APPLICATION FOR SUBMITTAL OF POST-APPROVAL DOCUMENT

School District/Owner: Yuba Community College District	DSA File Number: 58 C1
Project Name/School: Woodlland Community College	DSA Application Number 02 118286

see attached Addendum 2 for Narrative

2 M201 HVAC FLOOR PLAN - NORTH WING - UPPER LEVEL

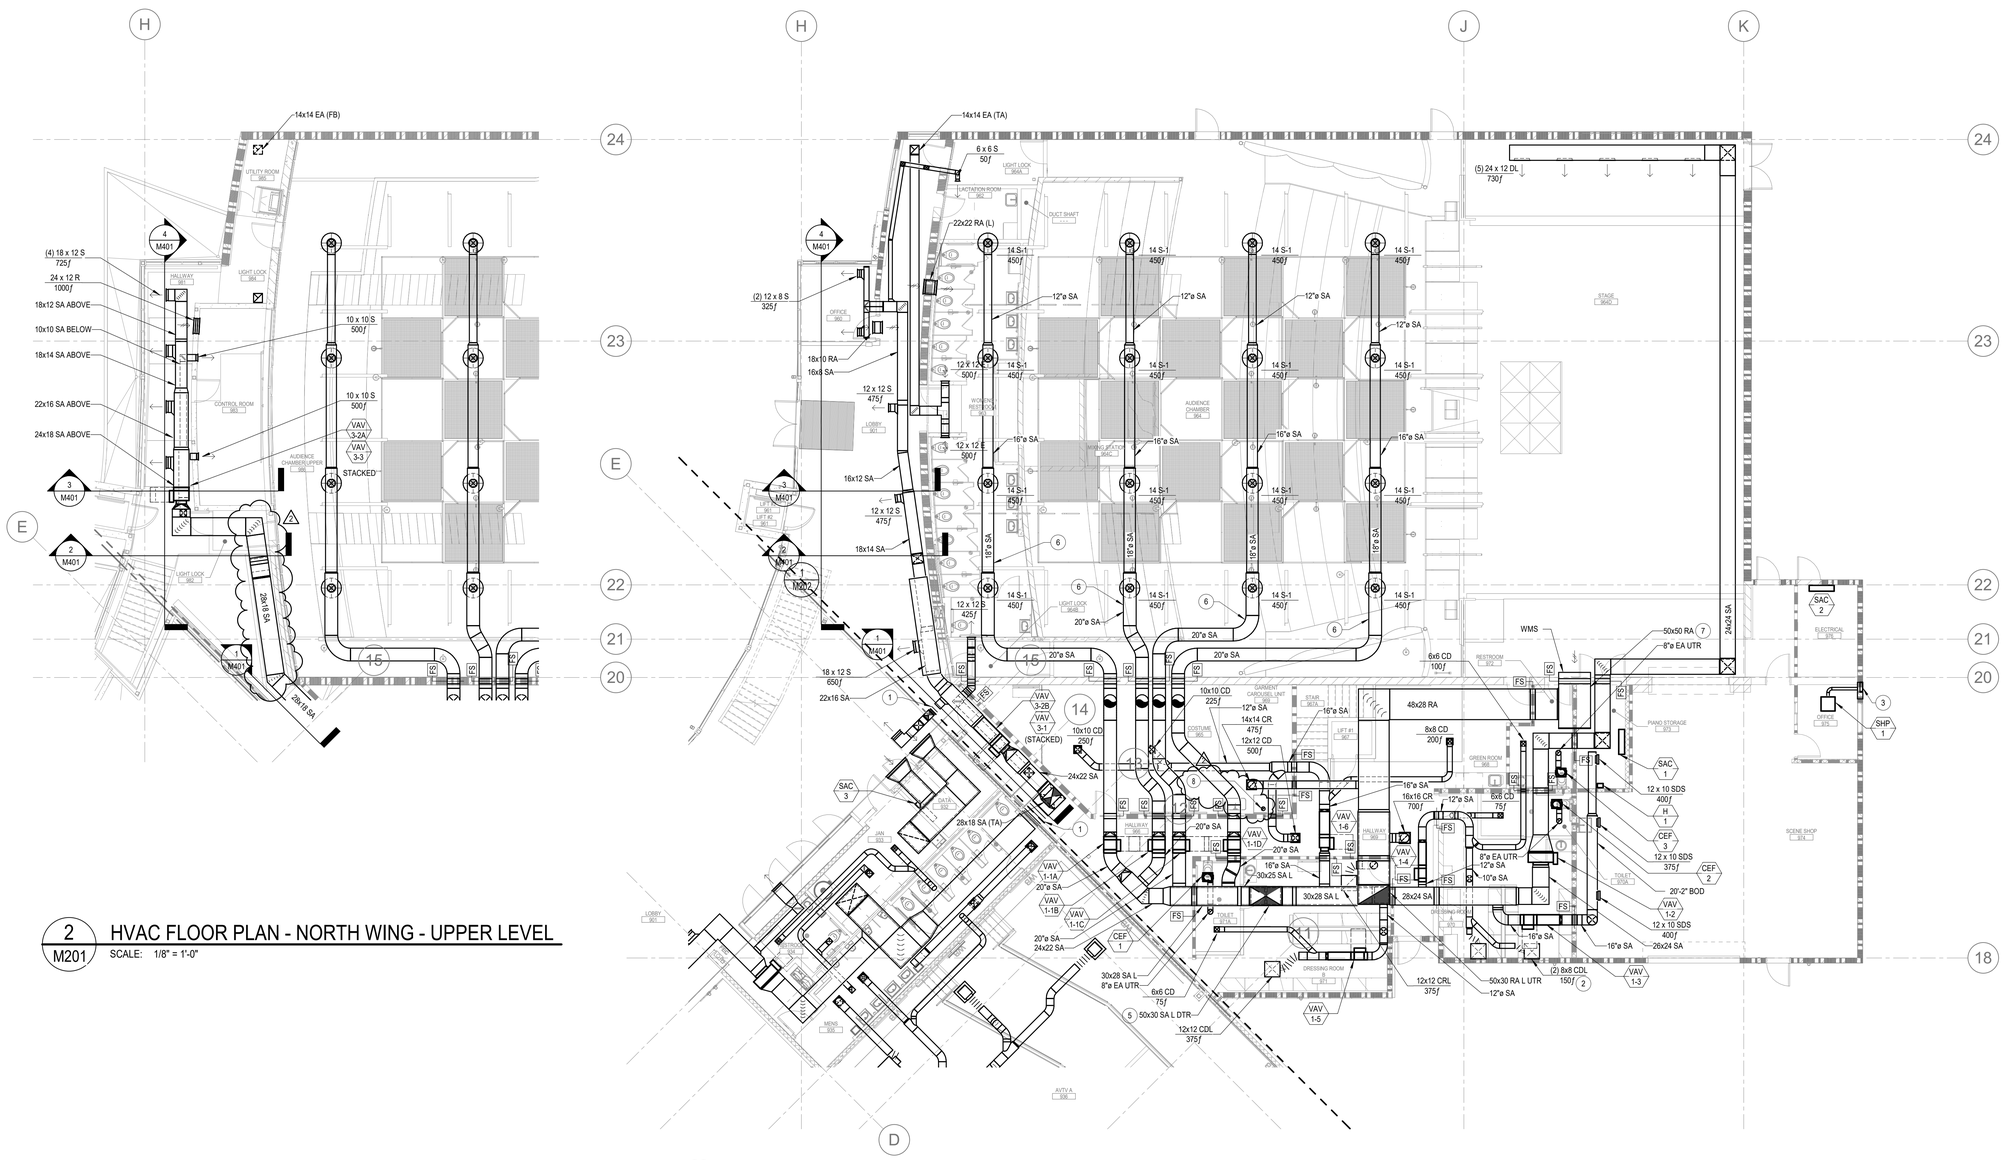
a. M201
   i. Aligned ductwork adjacent to theatre to travel inside ceiling soffit
   ii. Added dryer vent up to roof in 965 COSTUME

1 M202 HVAC FLOOR PLAN - SOUTH WING

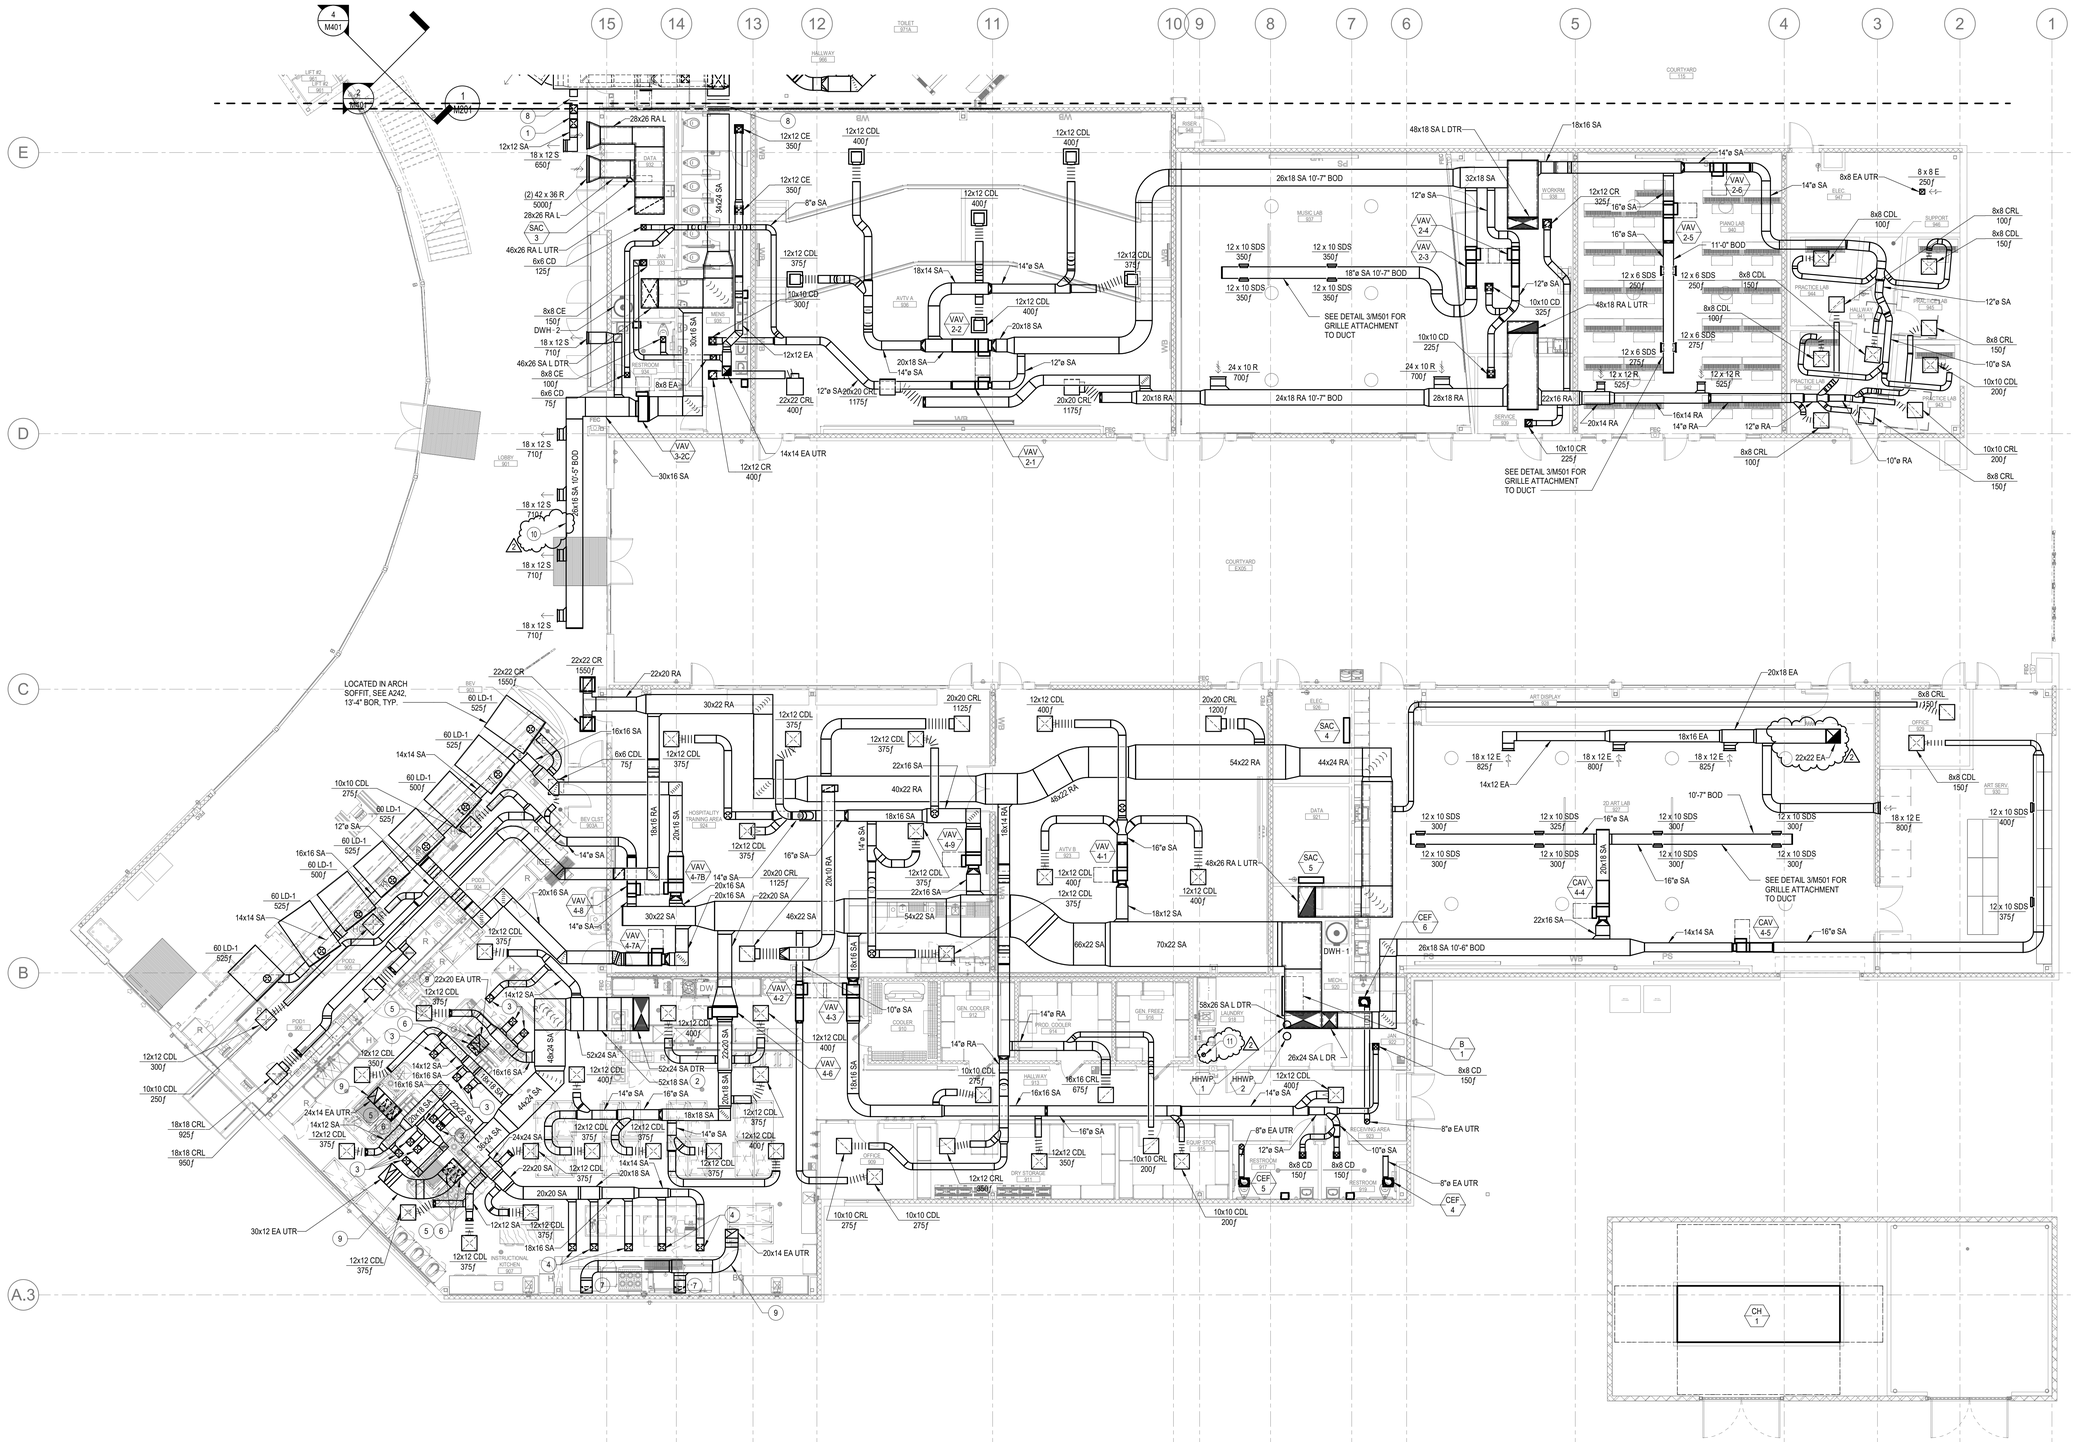
b. M202
   i. Added dryer vent up to roof in 918 LAUNDRY
   ii. Add access door note for duct in 901 LOBBY
   iii. Offset duct penetration up through roof to exhaust fan EF/4

1 / M302 HVAC PIPING FLOOR PLAN - SOUTH WING

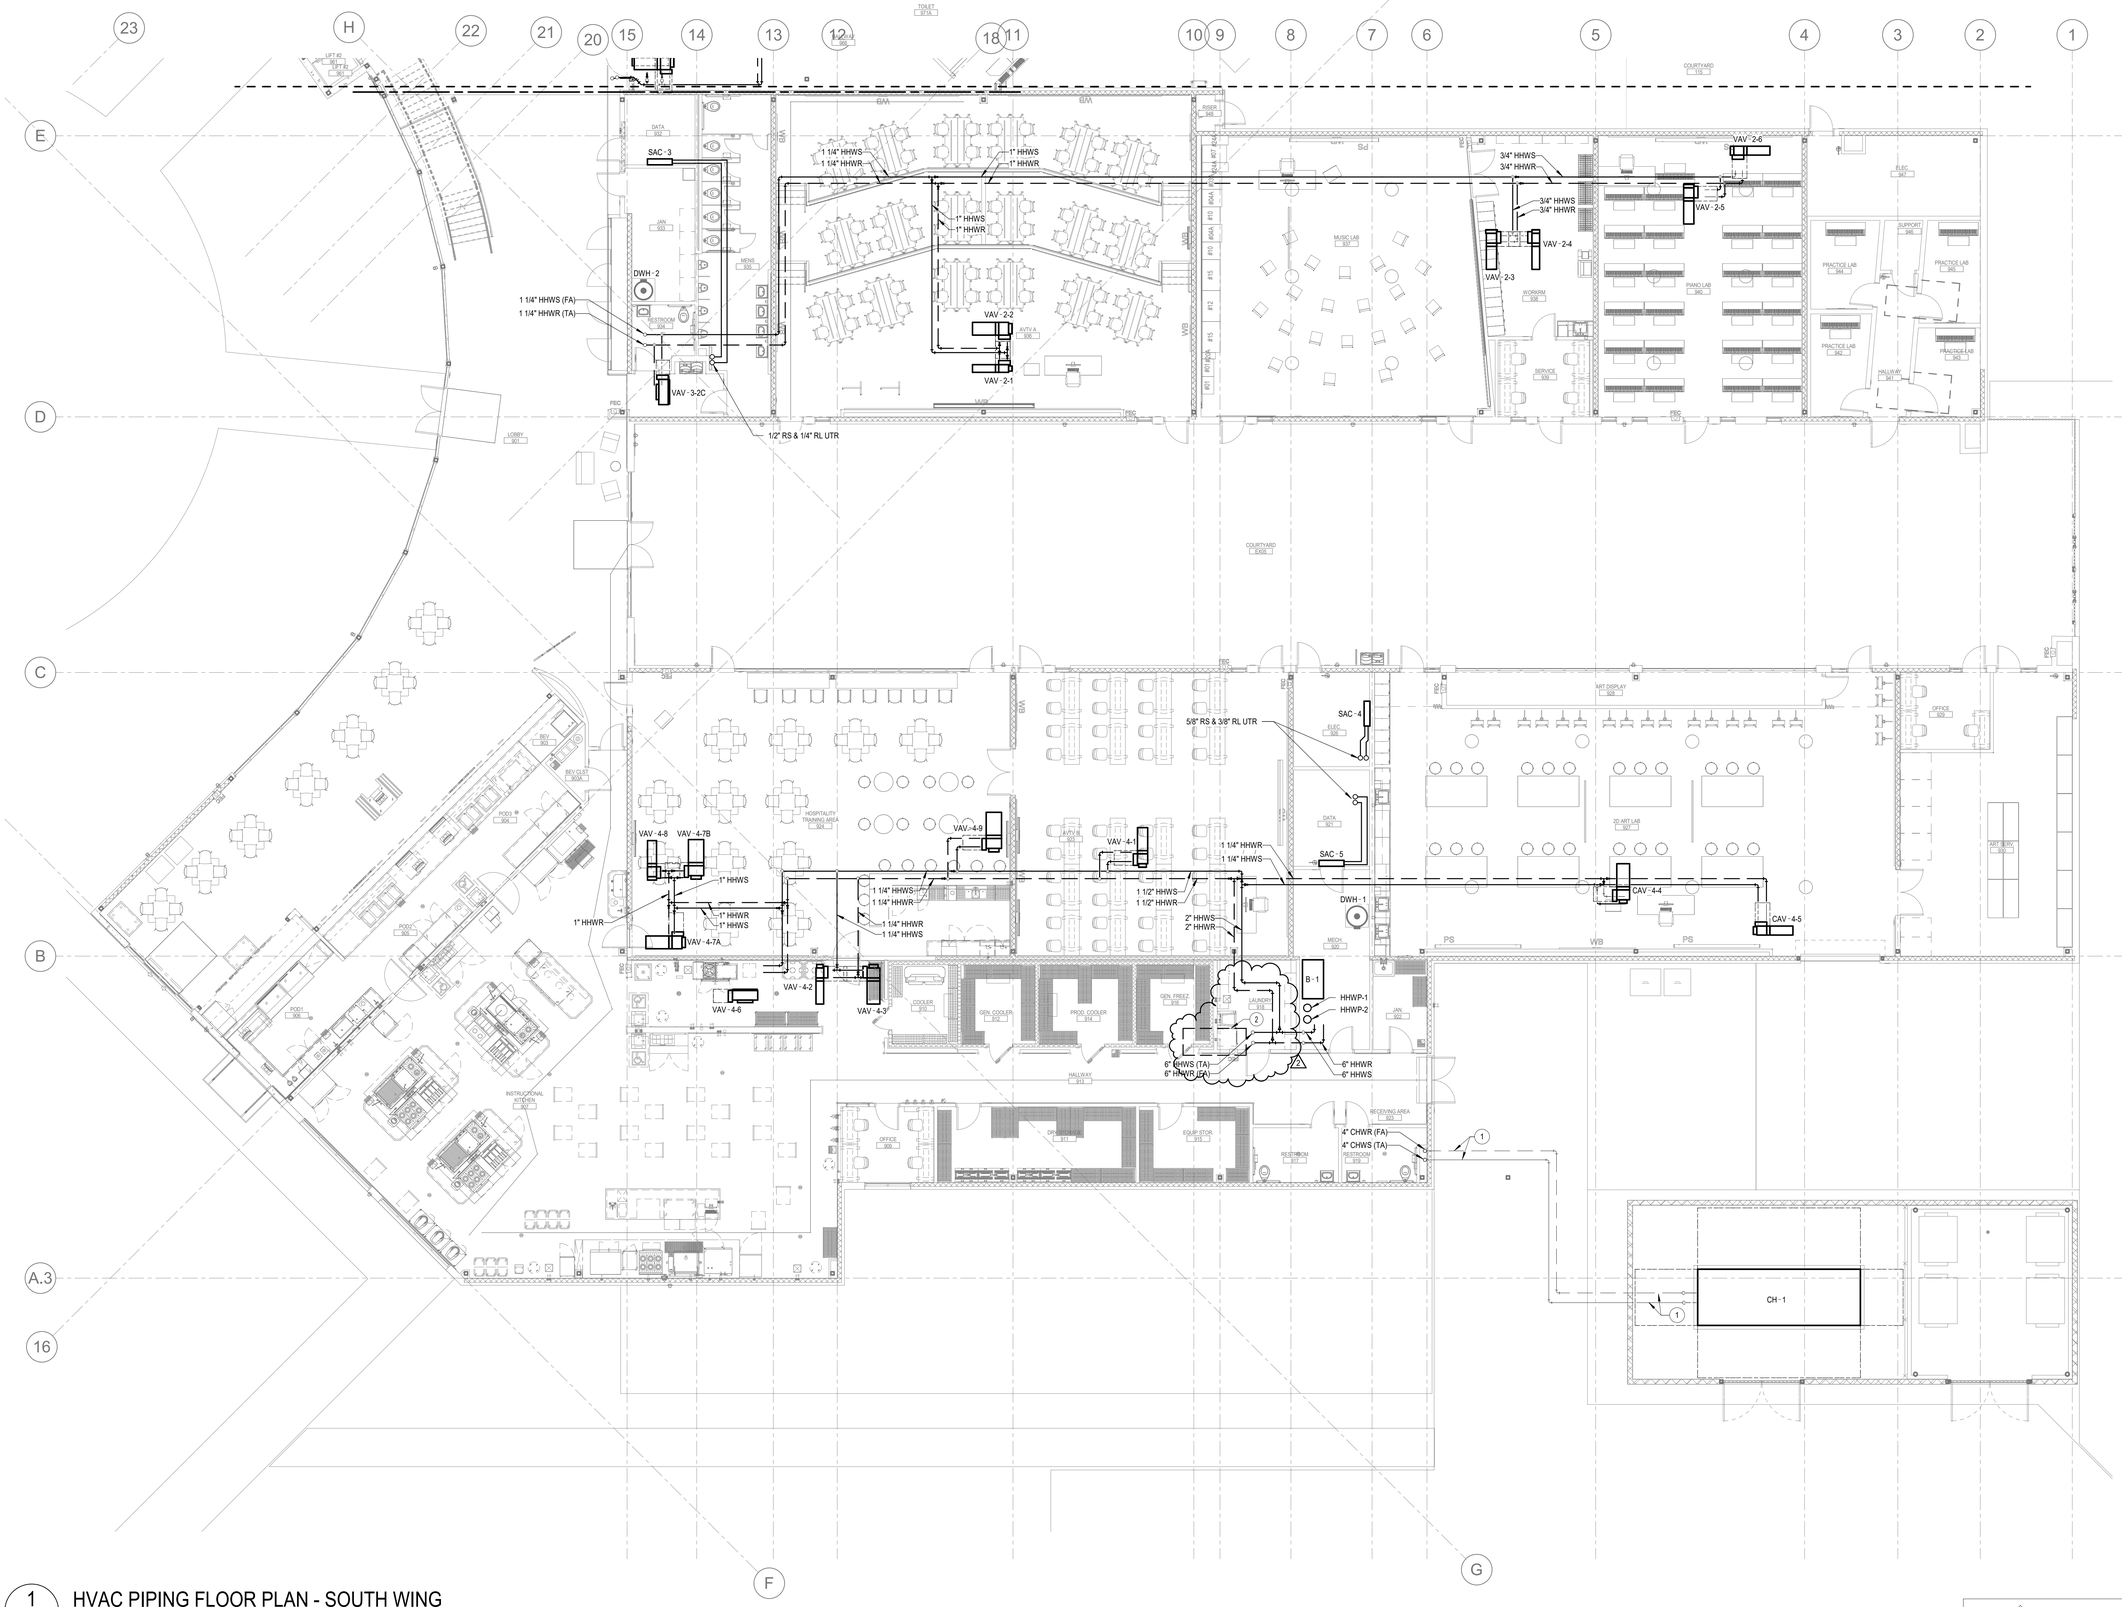
d. M302
   i. Add overhead clearance note for food service equipment

2 P201 PLUMBING FLOOR PLAN - NORTH WING - UPPER LEVEL

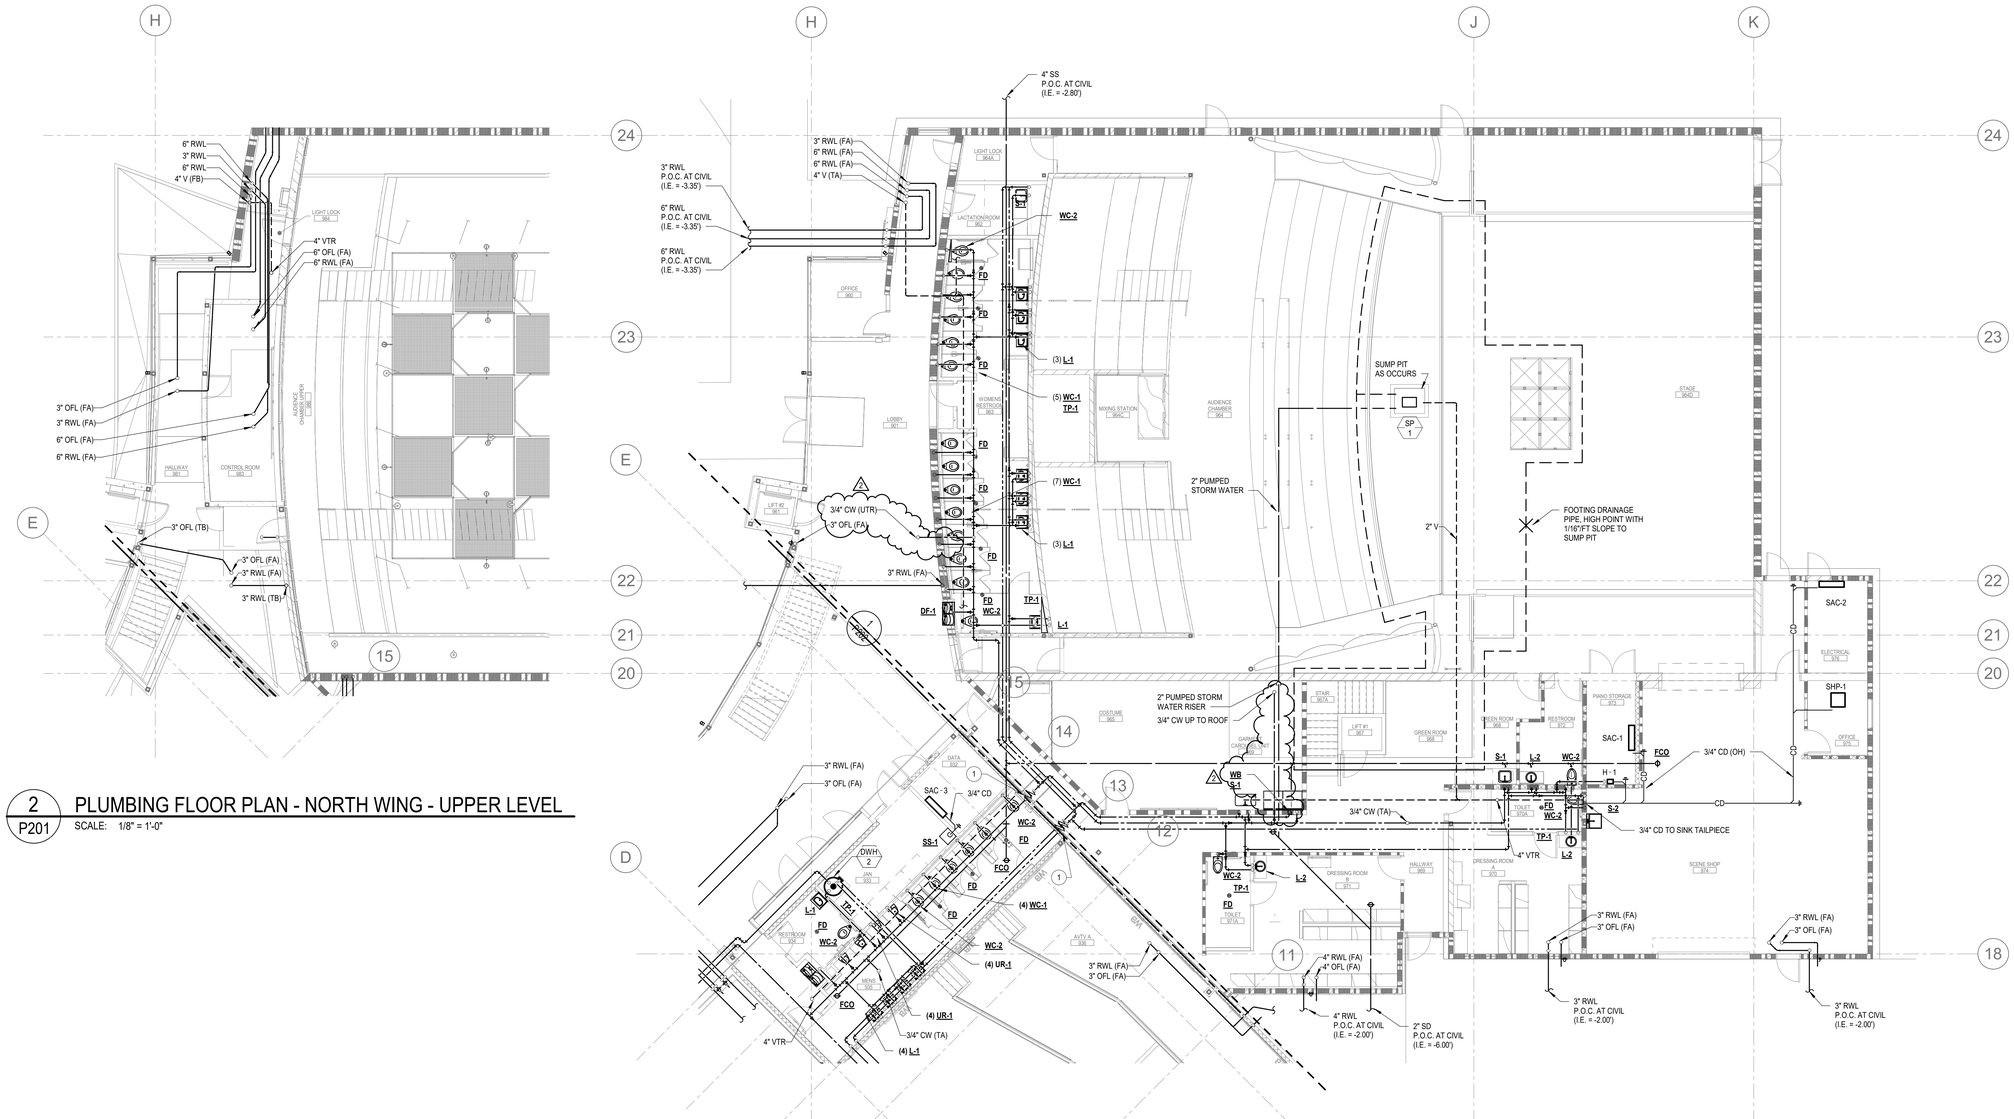
f. P201
   i. Add cold water routing up to hose bibbs on high roof
   ii. Add washing machine box in 965 COSTUME
